Addendum Number: 03

Owner: Robinson-Palestine Water Commission

Project Name: Water Treatment Plant and Campus

Project Number: 0210007.00

SHEET TITLE:
**PROCESS BUILDING
LIGHTING PLAN**

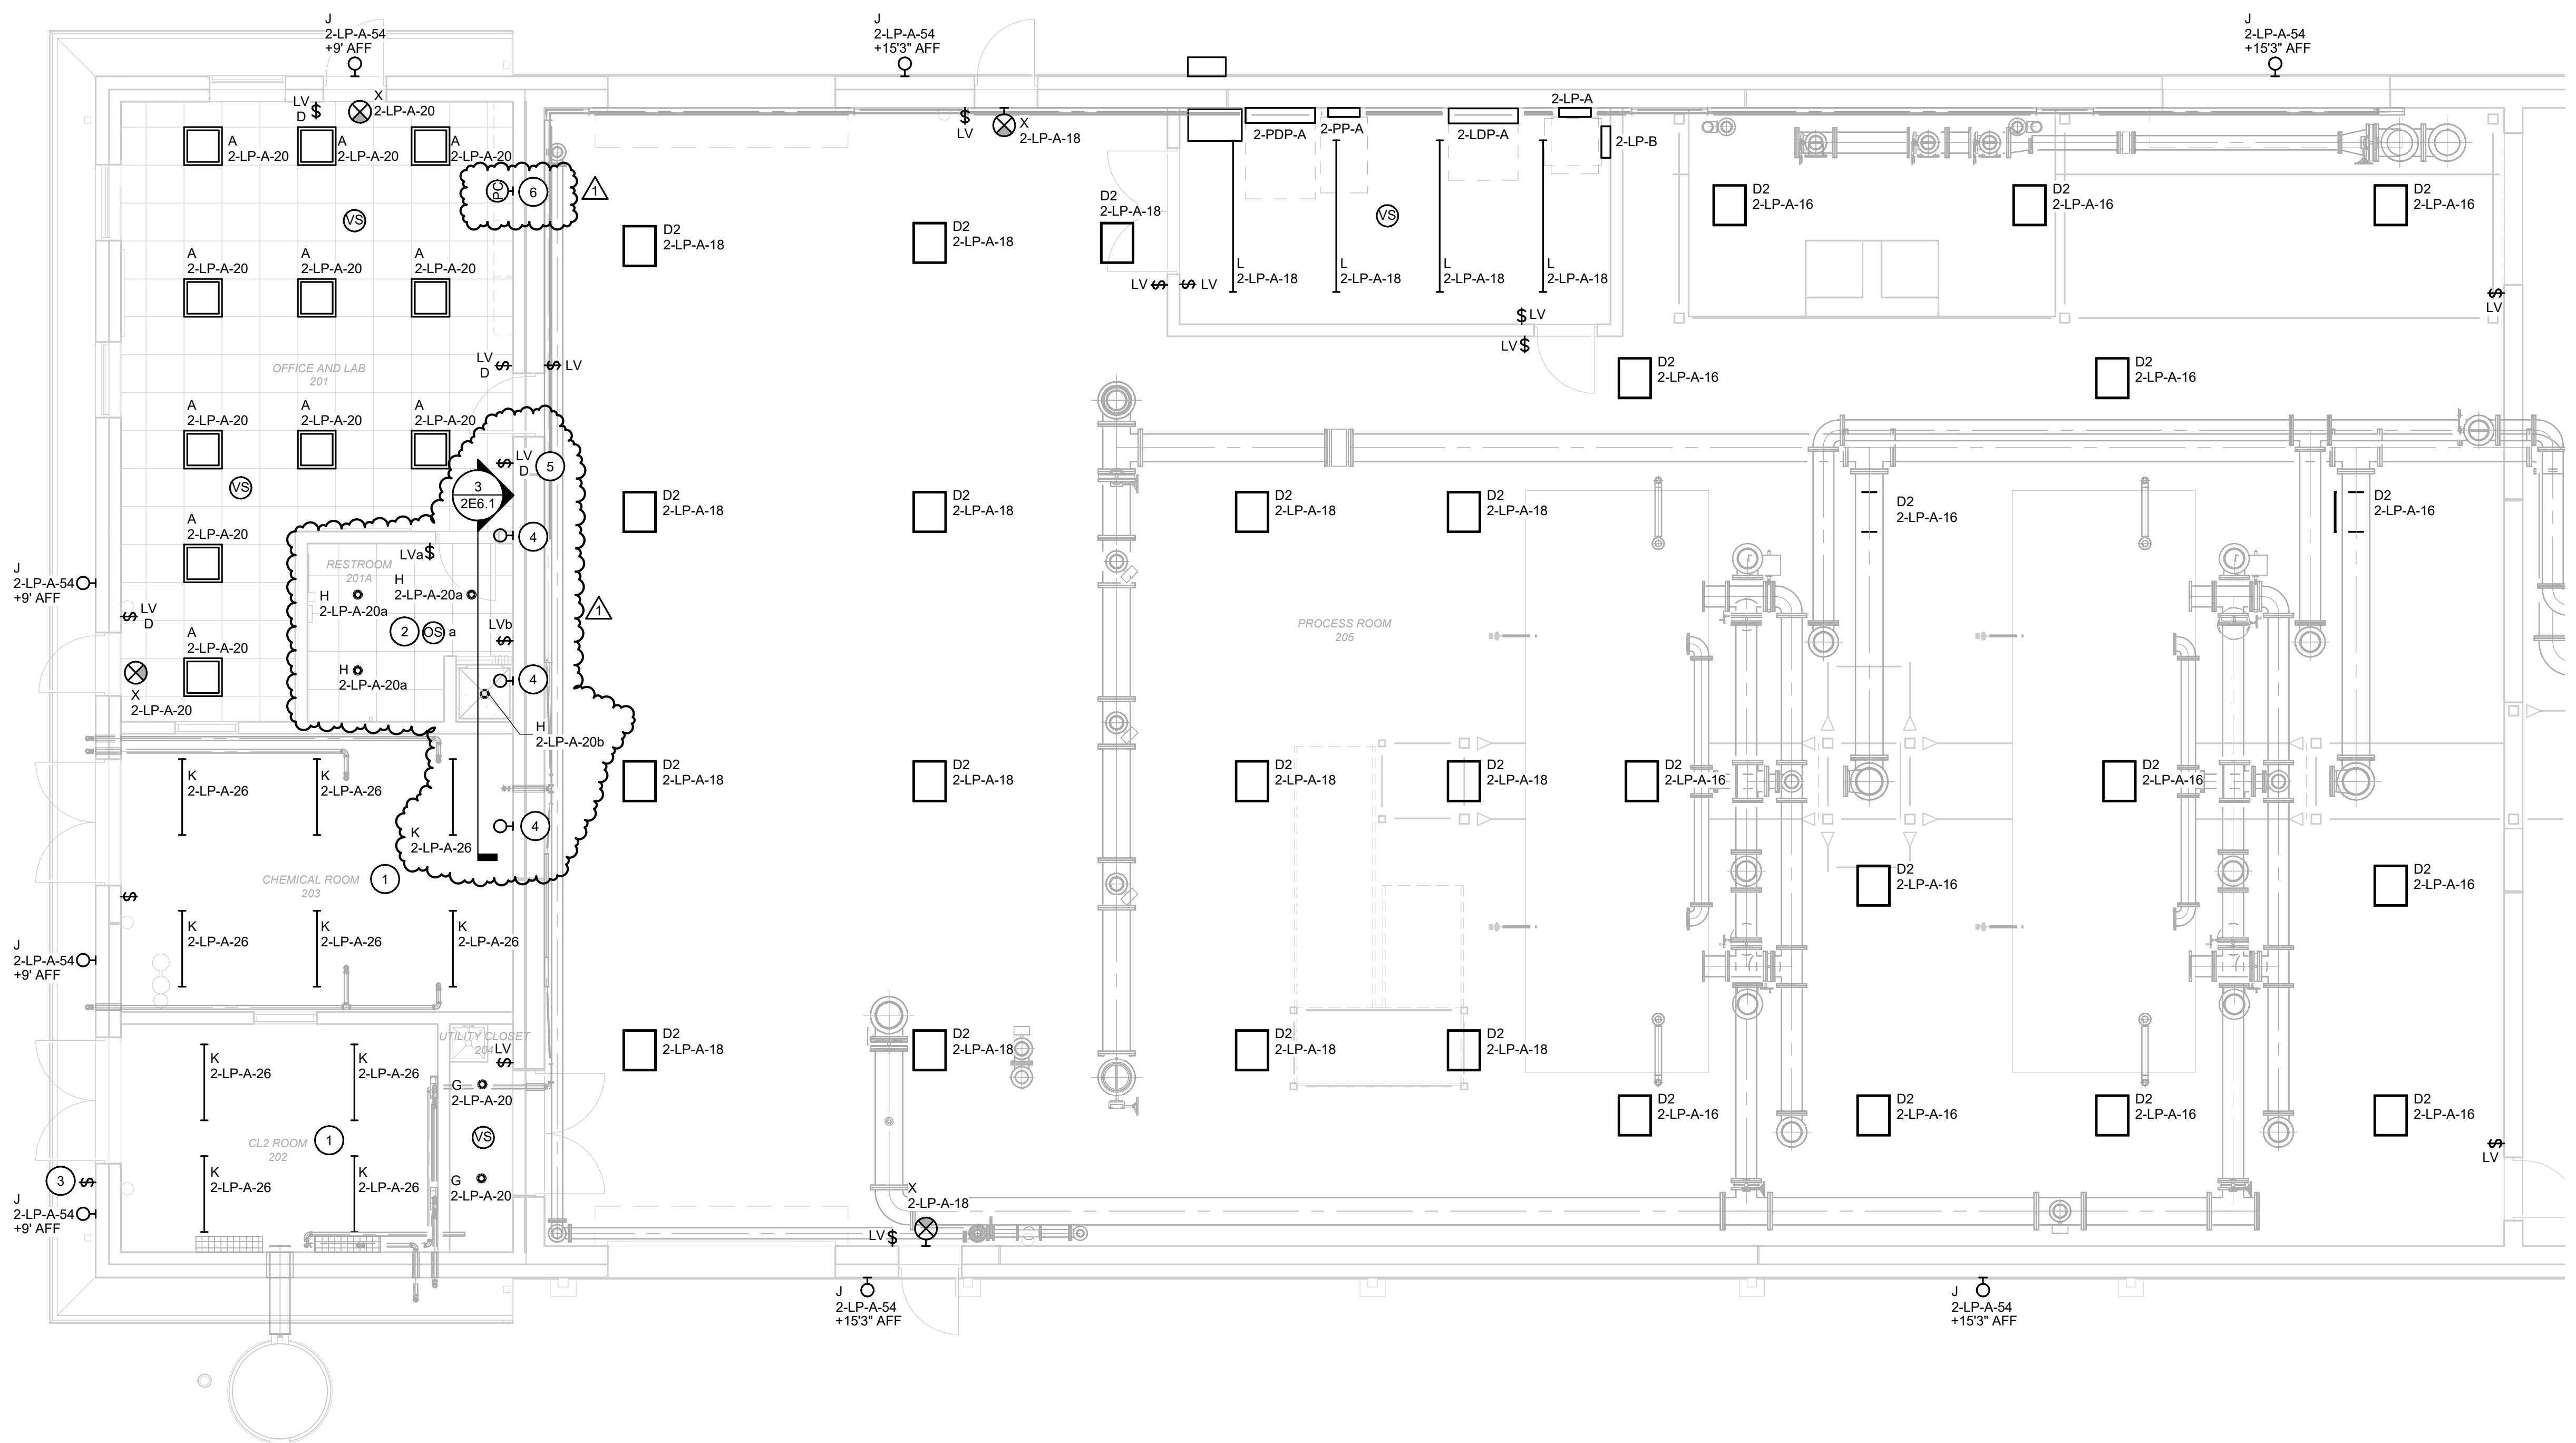
- 1E5.2 – OFFICE BUILDING SCHEDULES
 - ADD luminaire type M to luminaire schedule. See attached sheets.
- 2E1.1 – PROCESS BUILDING LIGHTING PLAN
 - ADD keynotes #4, 5, and 6. See attached sheets.

- ADD luminaire type M. See attached sheets.
 - ADD photocell and dimming switch. See attached sheets.
 - ADD light switch for shower and switch legs. See attached sheets.

- 1 PROVIDE PVC CONDUIT FOR ALL CONDUIT IN THIS SPACE.
- 2 INTERLOCK FAN CONTROL WITH LIGHTING OCCUPANCY CONTROLS.
- 3 LIGHTING CONTROL INTERLOCKED WITH FAN OPERATION. SEE DETAILS FOR CONTROL CIRCUIT.
- 4 SEE SECTION VIEW ON SHEET 2E6.1 FOR LUMINAIRE TYPE, CIRCUIT INFORMATION, AND MOUNTING LOCATION. VERIFY BRIGHTNESS LEVEL SET POINT WITH OWNER DURING COMMISSIONING.
- 5 DIMMING/ON/OFF OVERRIDE CONTROL FOR SIGN LIGHTING.
- 6 PROVIDE PHOTOCELL MOUNTED ON BUILDING EXTERIOR. PHOTOCELL TO PROVIDE ON/OFF CONTROL FOR SIGN LIGHTING. SEE 2E6.1 DETAIL 3.

1 GROUND STORAGE TANK DETAIL

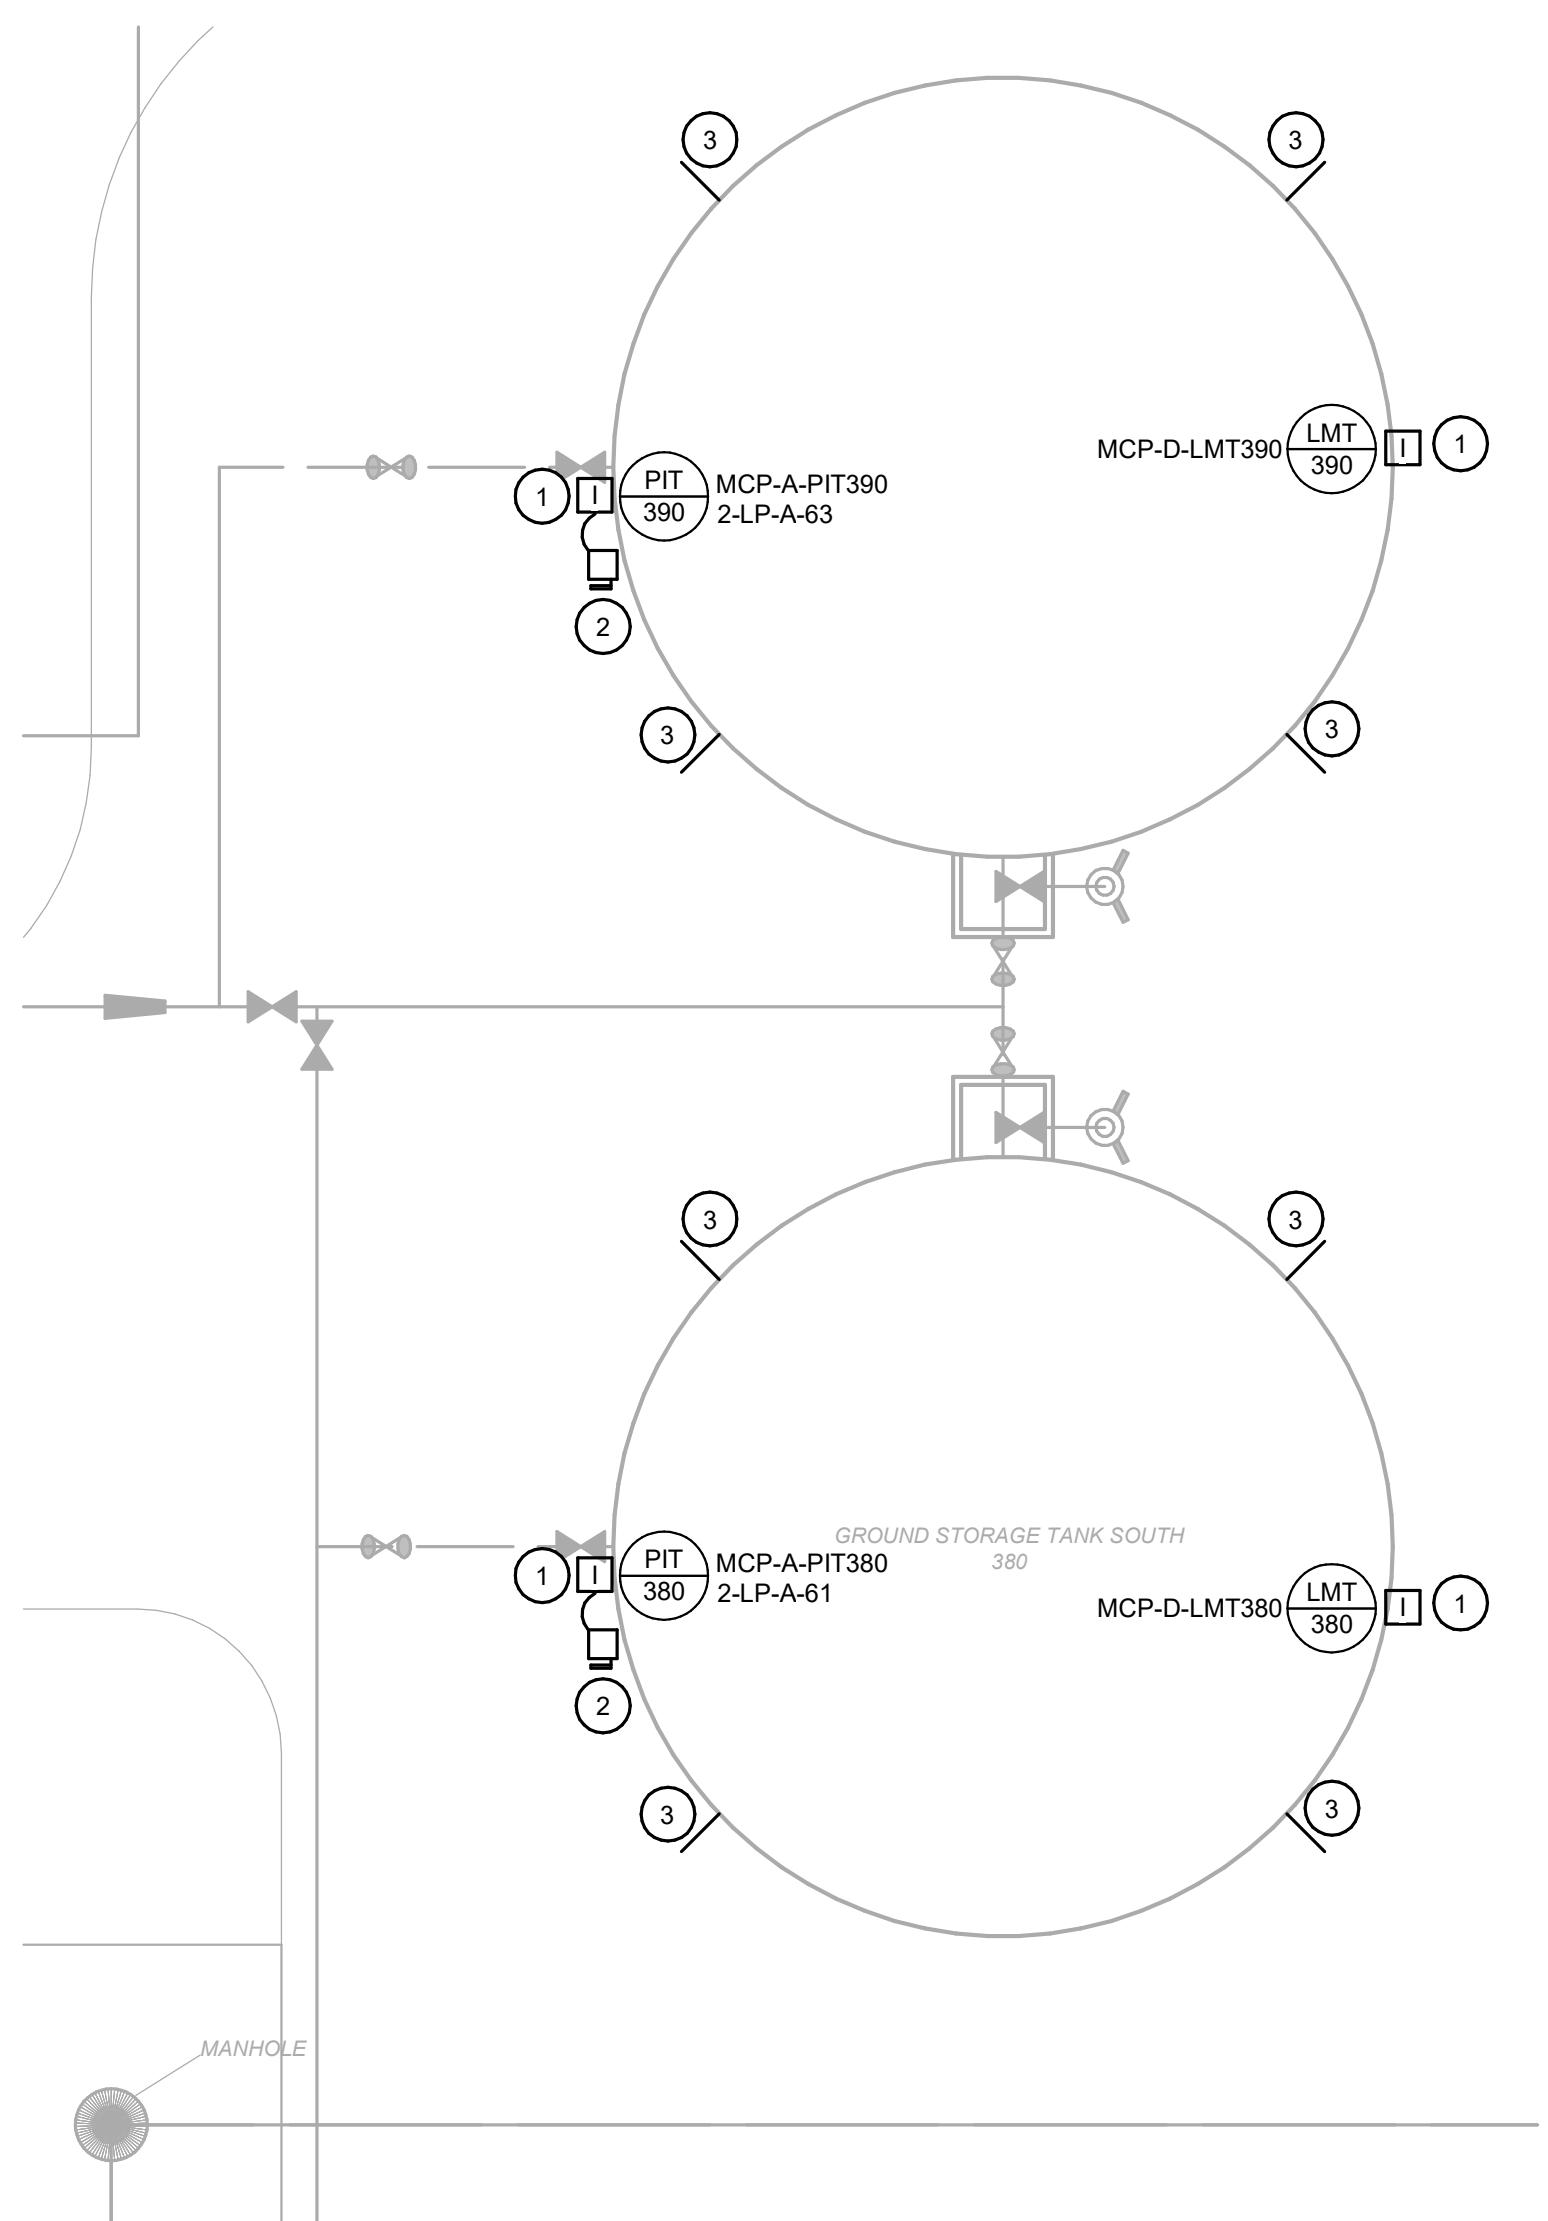
Sheet 2E6.1 Keynotes 1 and 2 call out heat trace on the water sampling line; however, I do not see a corresponding detail or specification.

Could you please clarify the requirements for this heat trace?

Heat trace will be provided later, EC just needs to provide the circuit for now.

3 PROCESS BUILDING SIGN LIGHTING

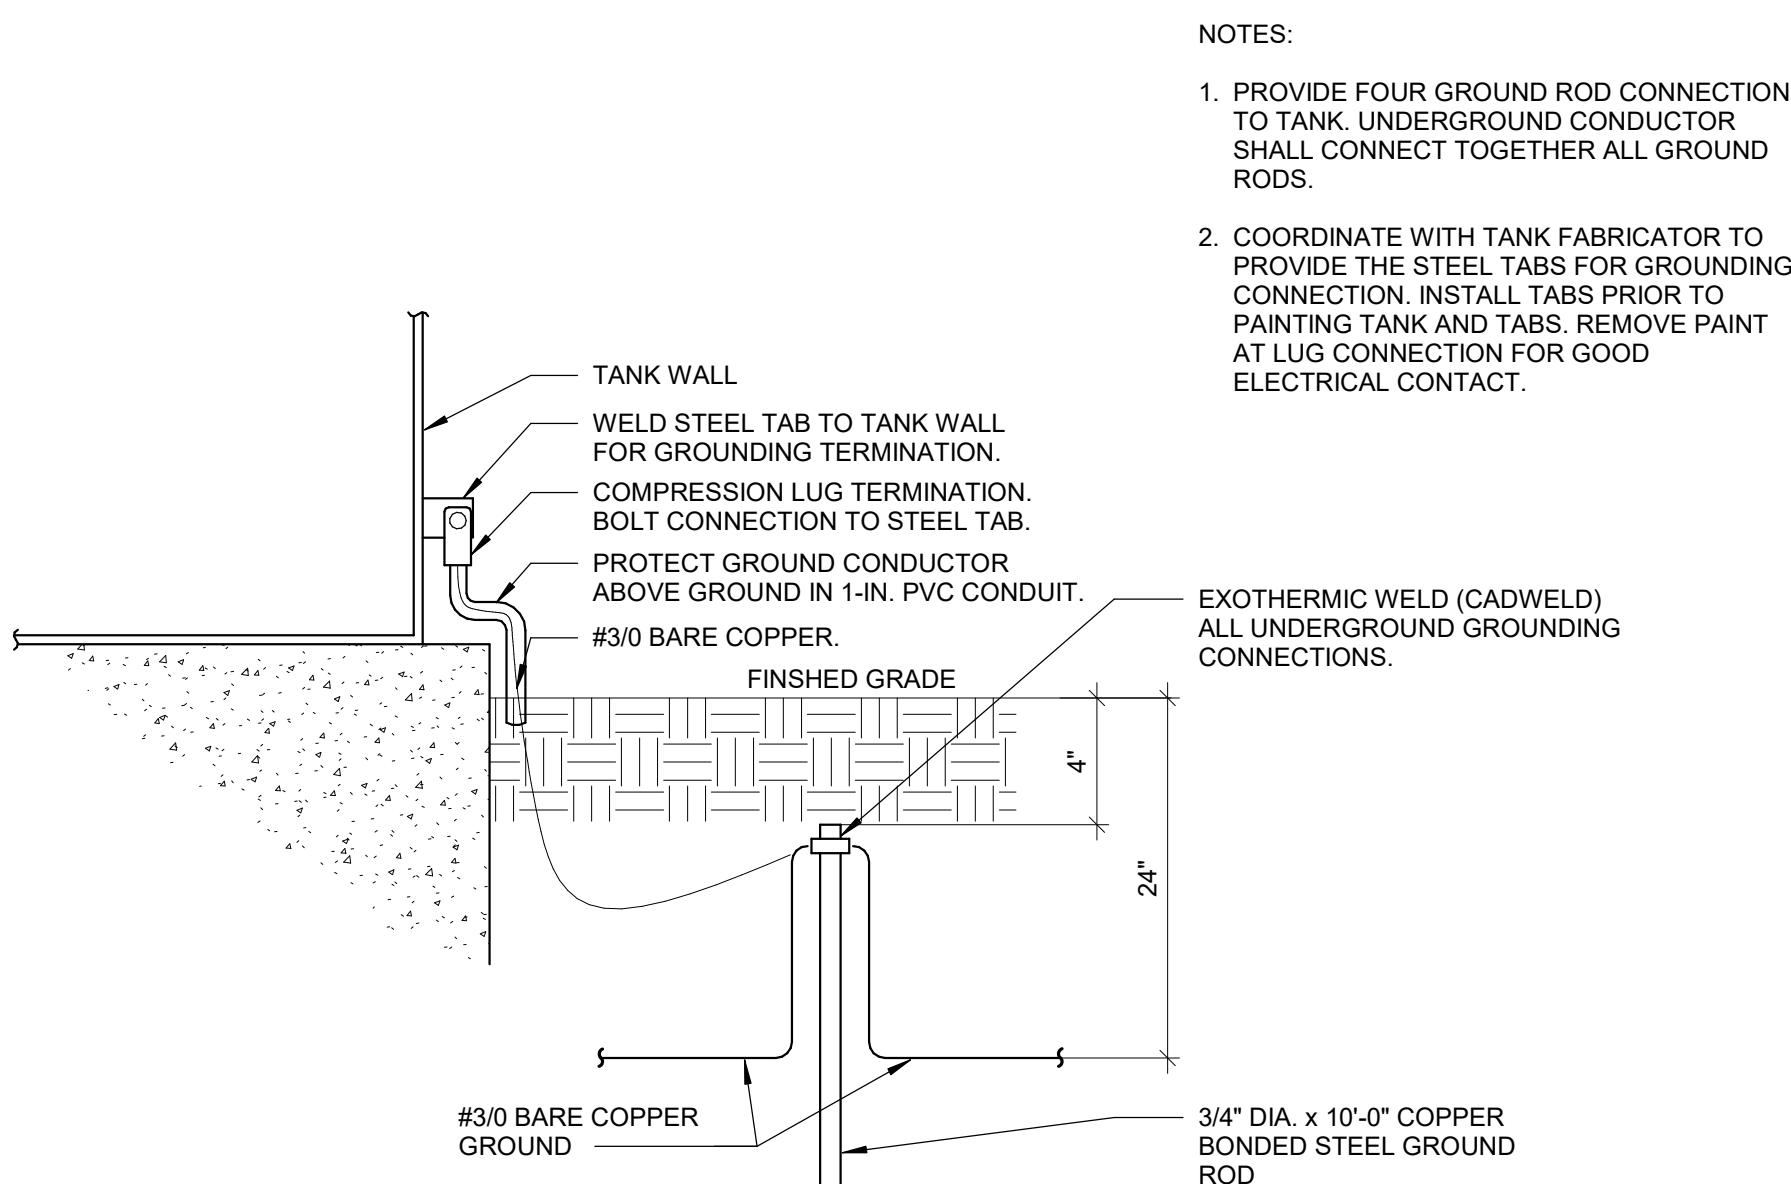
- ADD luminaire type M to luminaire schedule. See attached sheets.
- 2E6.1 – PROCESS BUILDING DETAILS
 - ADD detail #3 for sign lighting. See attached sheets.
